ADDENDUM NUMBER: ONE

**ISSUED BY: SEPW Architecture Inc.
206 – 1275 Broad Street, Regina, SK S4R 1Y2
PH. (306) 569-2255**

**PROJECT: ESDC – PPT REGINA AMALGAMATION
REGINA, SK**

Dimensions:

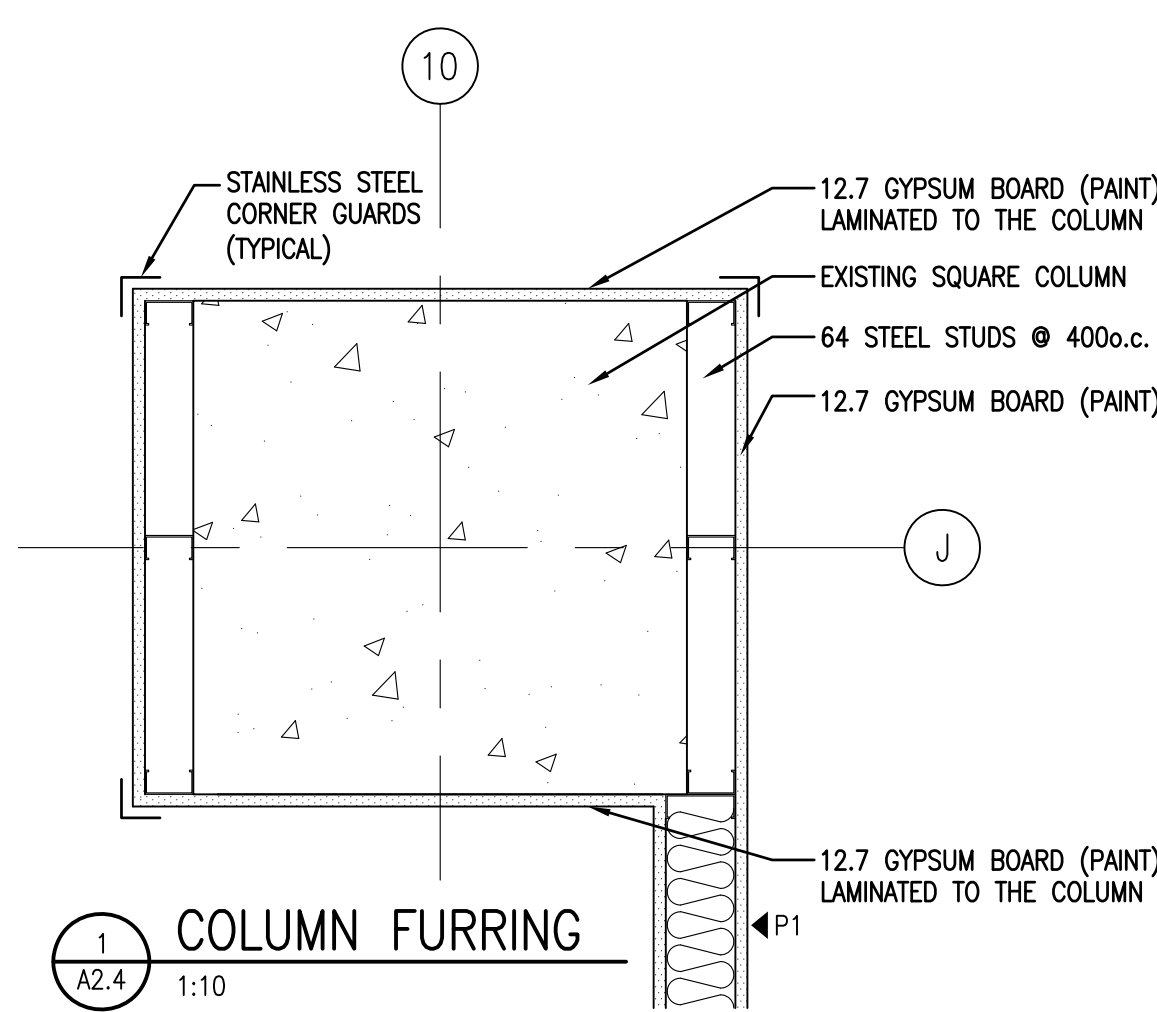
- .1 REPLACE this drawing in its entirety with Drawing A4.4R1 accompanying this addendum.
- .2 Reference Detail 5, Column Furring; REPLACE this detail as per Drawing A4.4R1 accompanying this addendum.

1	MAIN FLOOR LIGHTING PLAN
E2.2	1:100

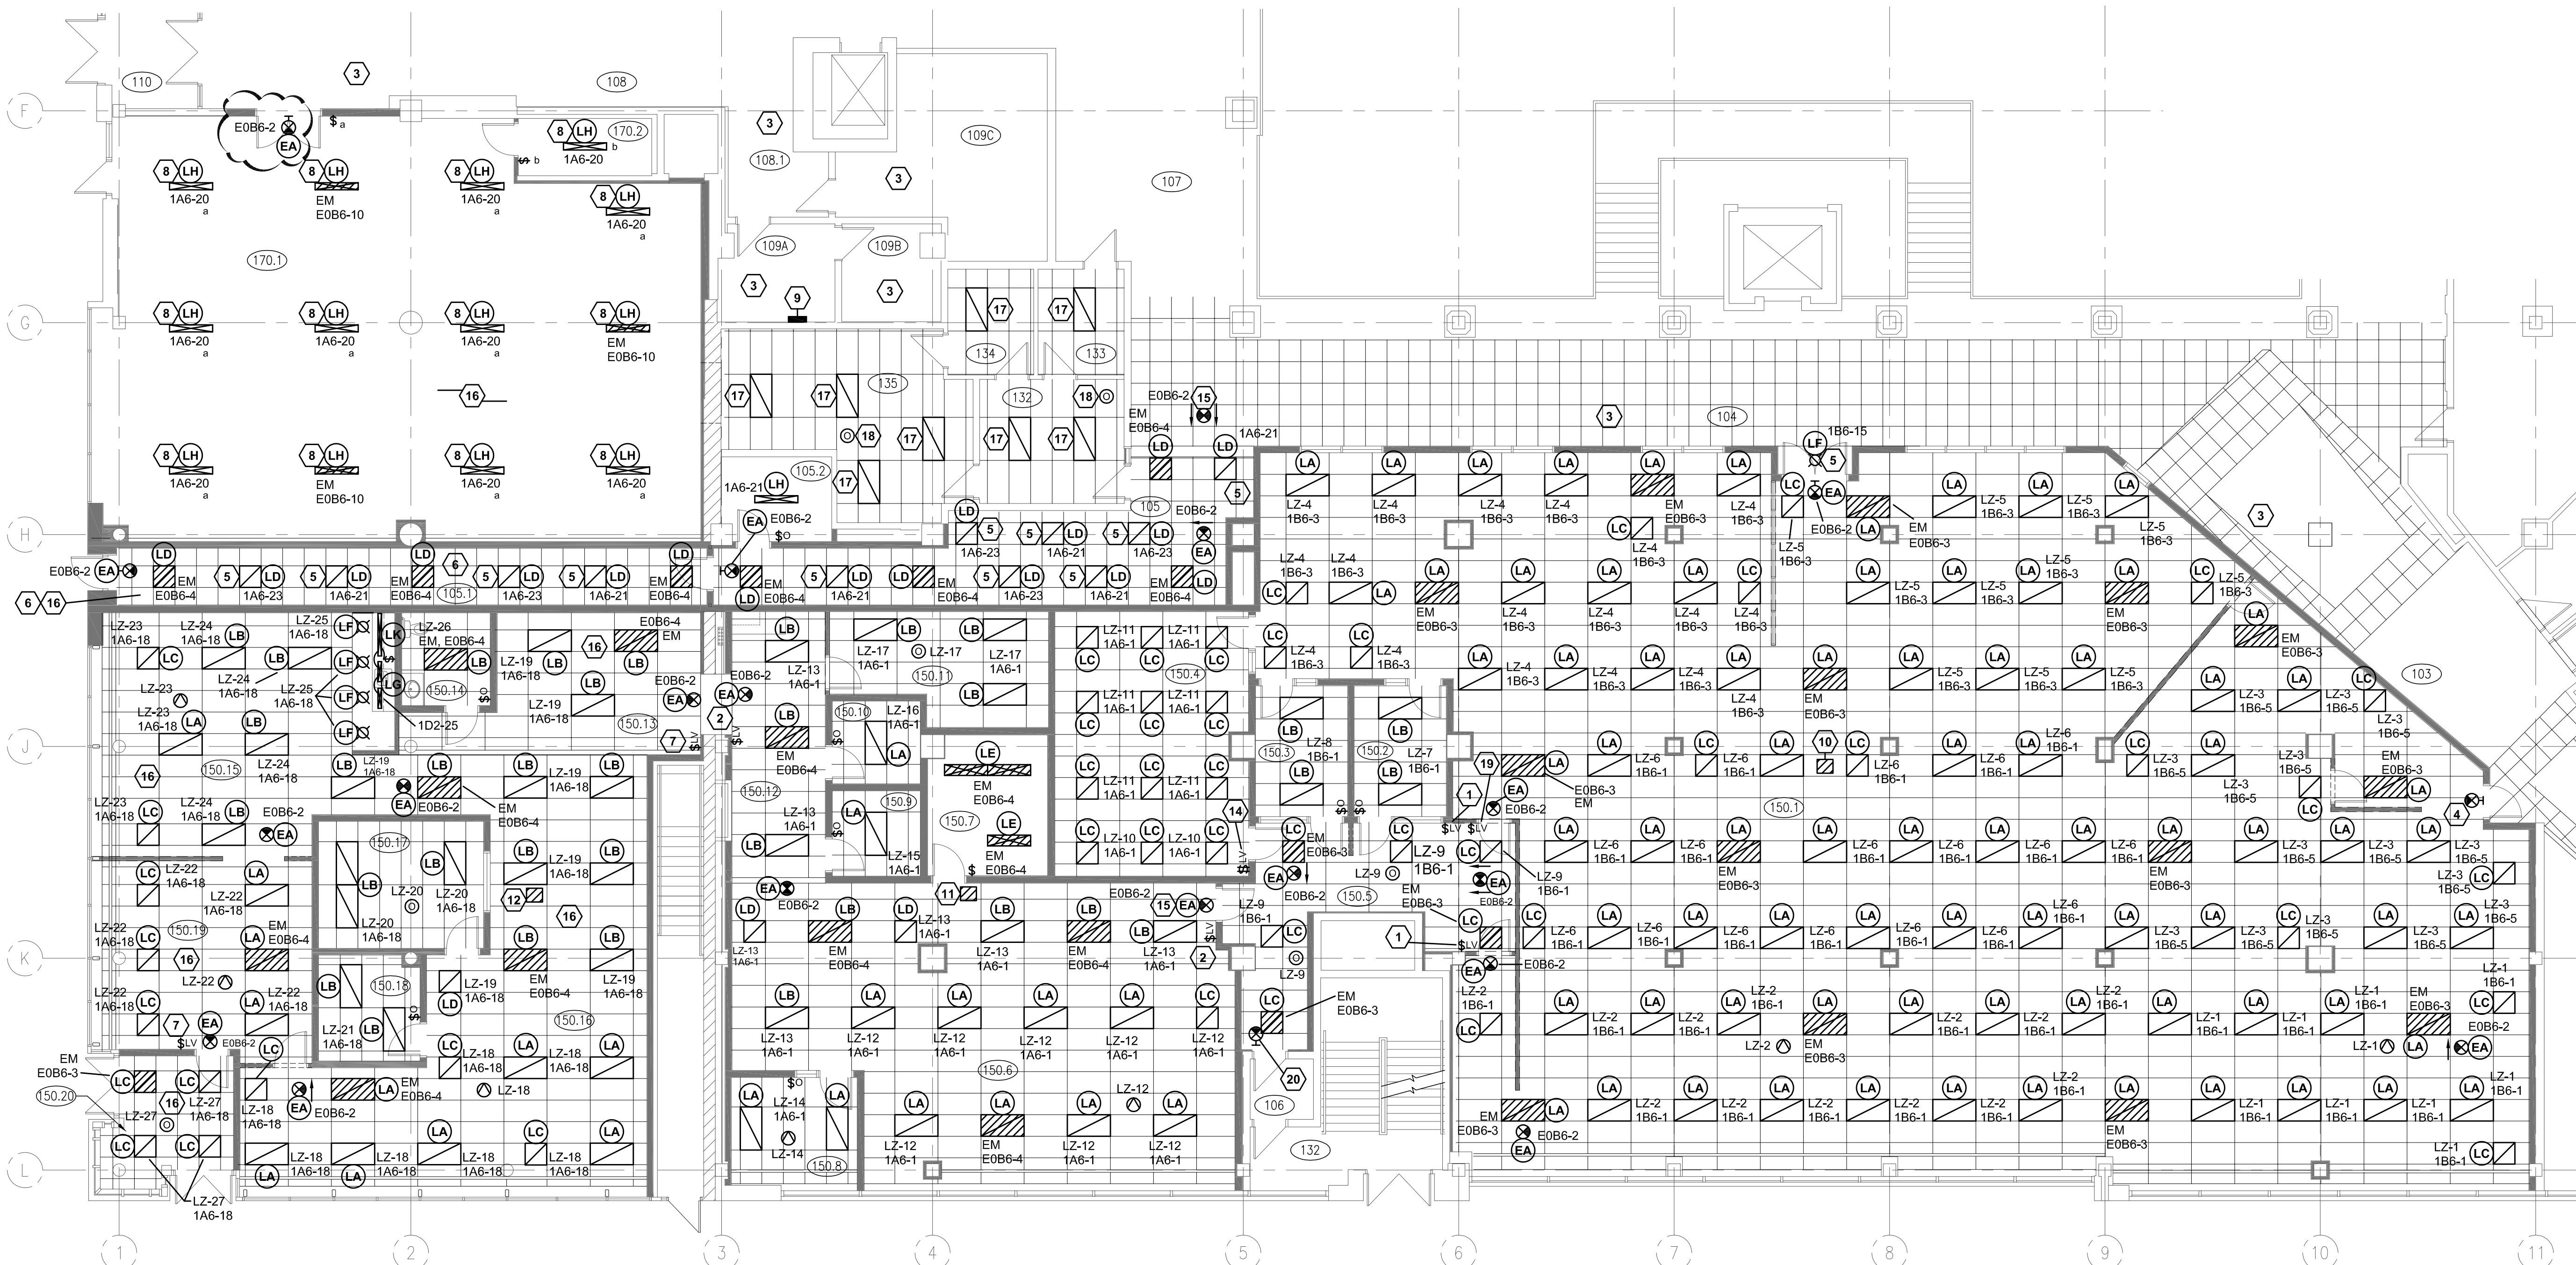
- .1 Reference Detail 1, Main Floor Lighting Plan; Room 170.1; PROVIDE and install one type EA light fixture above Door 170.1.1. Circuit to circuit E0B6-2. Refer to Drawing E2.2R1 accompanying this addendum.

1 | MAIN FLOOR FIRE ALARM AND SECURITY ROUGH IN PLAN

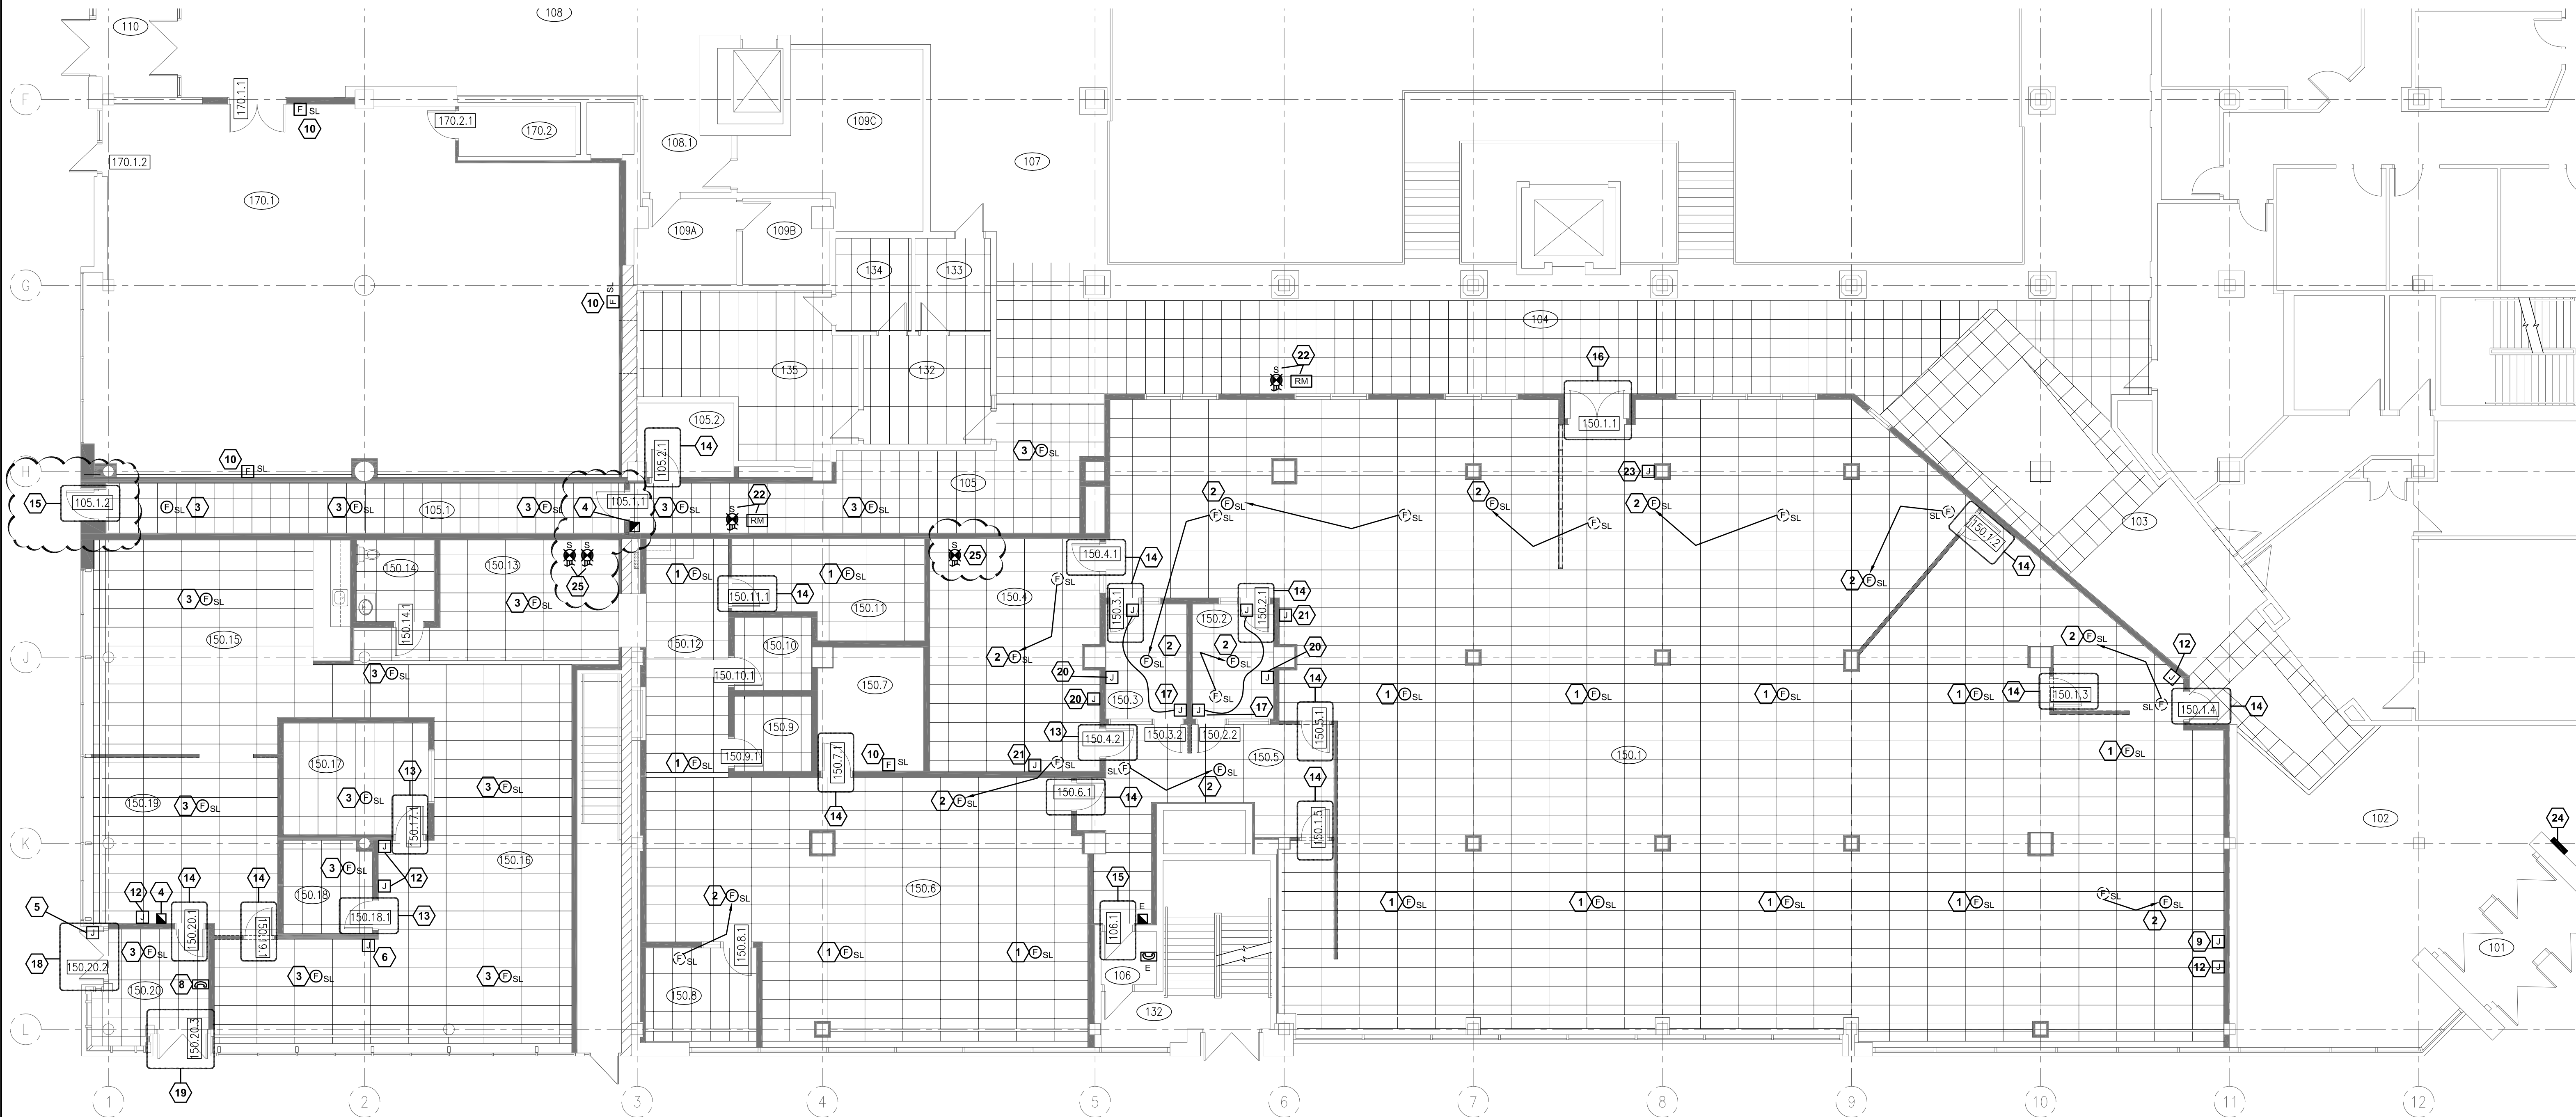
- .1 Reference Detail 1, Main Floor Fire Alarm and Security Rough In Plan; Room 105.1; DELETE installation of fire alarm pull station at Door 105.1.2. Refer to Drawing E2.5R1 accompanying this addendum.

- .2 Reference Detail 1, Main Floor Fire Alarm and Security Rough In Plan; Room 105.1; PROVIDE and install fire alarm pull station at Door 105.1.1. Refer to Drawing E2.5R1 accompanying this addendum.

- .3 Reference Detail 1, Main Floor Fire Alarm and Security Rough In Plan; Room 105.4; PROVIDE and install one duct smoke detector in mechanical ductwork prior to ductwork crossing into Corridor 105. Connect duct smoke detector to the main floor initiating circuit in the existing zone in which it is located. Refer to Drawing E2.5R1 accompanying this addendum.

- .4 Reference Detail 1, Main Floor Fire Alarm and Security Rough In Plan; Room 105.13; PROVIDE and install two duct smoke detectors in mechanical ductwork prior to ductwork crossing into Corridor 105.1. Connect duct smoke detector to the main floor initiating circuit in the existing zone in which it is located. Refer to Drawing E2.5R1 accompanying this addendum.
